## CITY OF RIALTO CONTRACT CHANGE ORDER

Date: 03/10/2020  
Project No: 170808  
Project: Metrolink Parking Lot Expansion  
Project Phase 2

Change Order No: 01  
Purchase Order No: 2019-1288  
Account Number(s): 223-500-4408-3001-170808-05

CITY OF RIALTO  
METROLINK PARKING LOT EXPANSION - PHASE 2  
DRAINAGE DETAIL PLAN

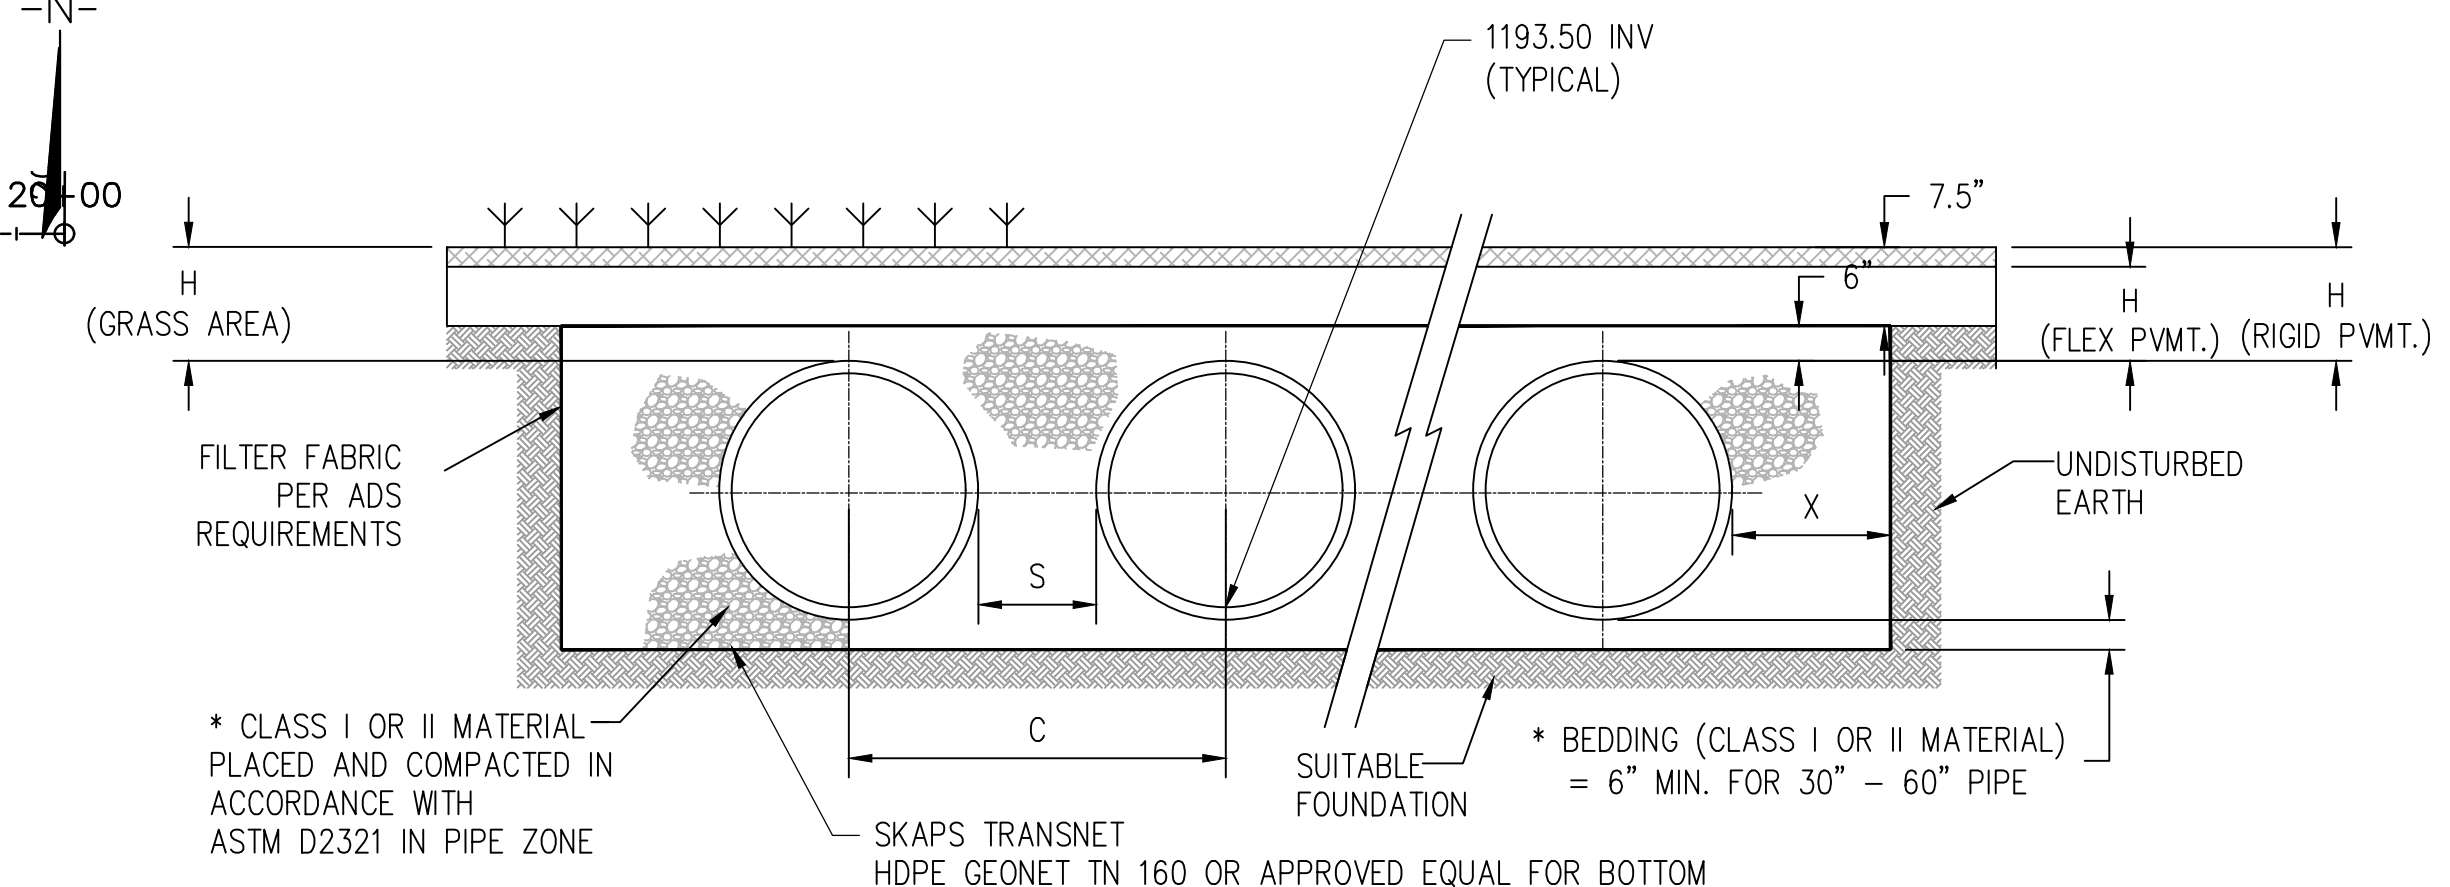
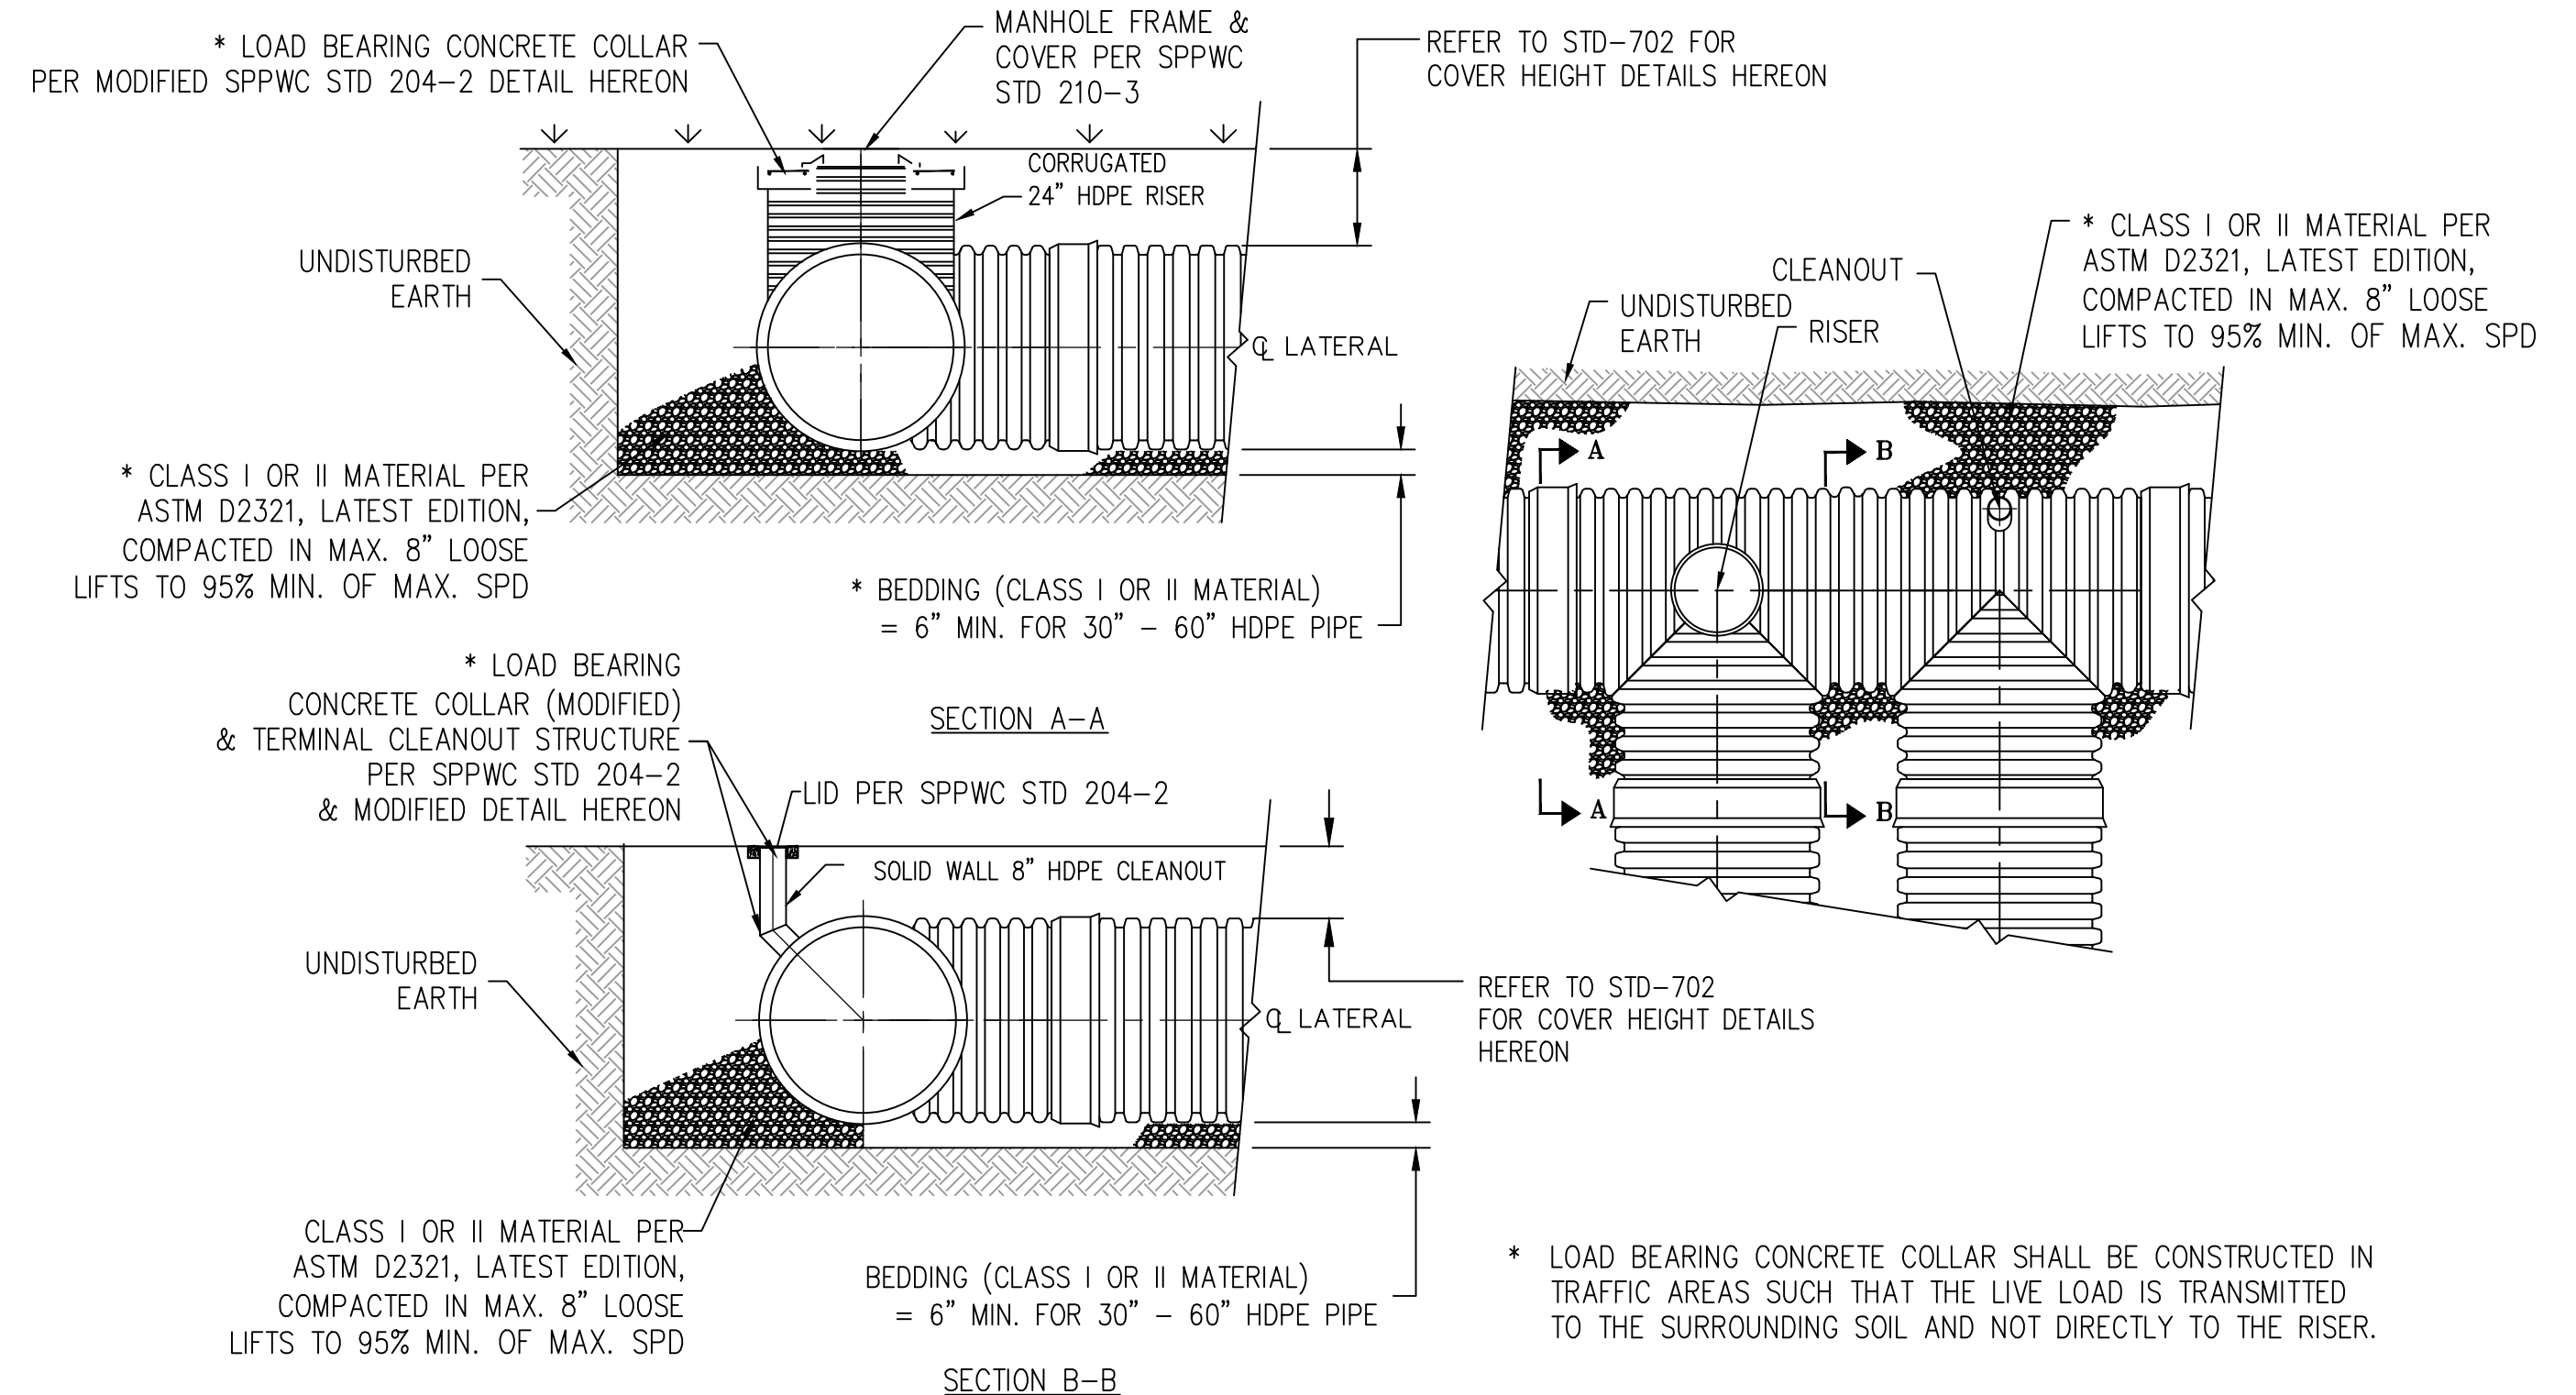
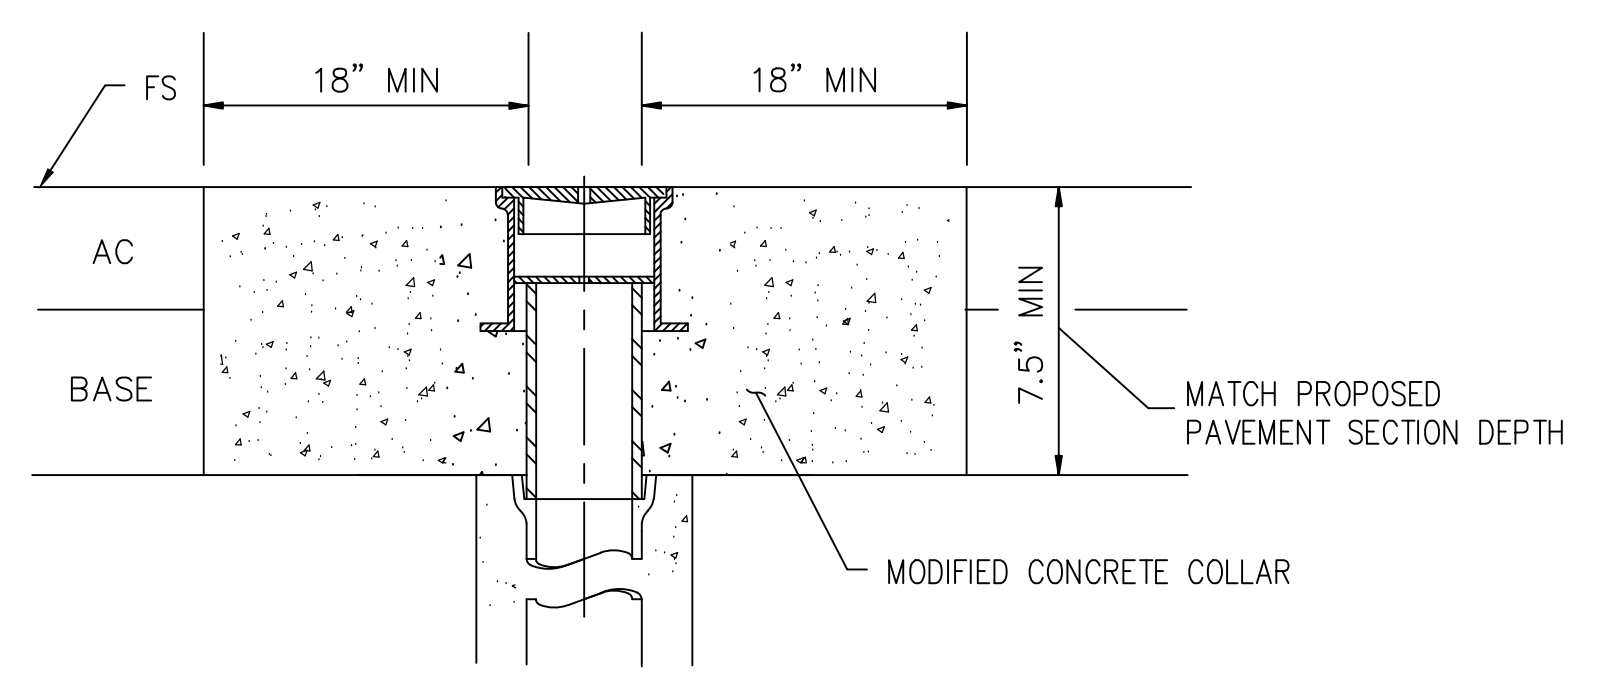
**CCO#1 - Item 1:** Additional excavation work was required to accommodate changes to the excavation limits for the storm drain detention system.

**CCO#1 - Item 1:** The Contractor's surveyors requested grading limits stationing for the storm drain detention system from the designer. Stationing marked on the drawing provided by the designer increased the area of excavation from 3,456 sq. ft. to 4,047 sq. ft. at an average cut of 5.3 feet; therefore, additional grading, additional export, and additional import of rock was required.

- 1 Engineer of record provided new stations for the excavation limits which made the excavation increase from 3,456 sf to 4,047 sf at and average cut of 5.3ft. Excess soil will be hauled off and additional 3/4" crush rock is required to be imported.

**CCO#1 - Item 1:** Extra work will be paid at the agreed price of **\$7,000.00**. This payment shall include equipment, labor, materials and any incidentals associated with Change Order Proposal (COP) No. 01 and no additional payment will be made.
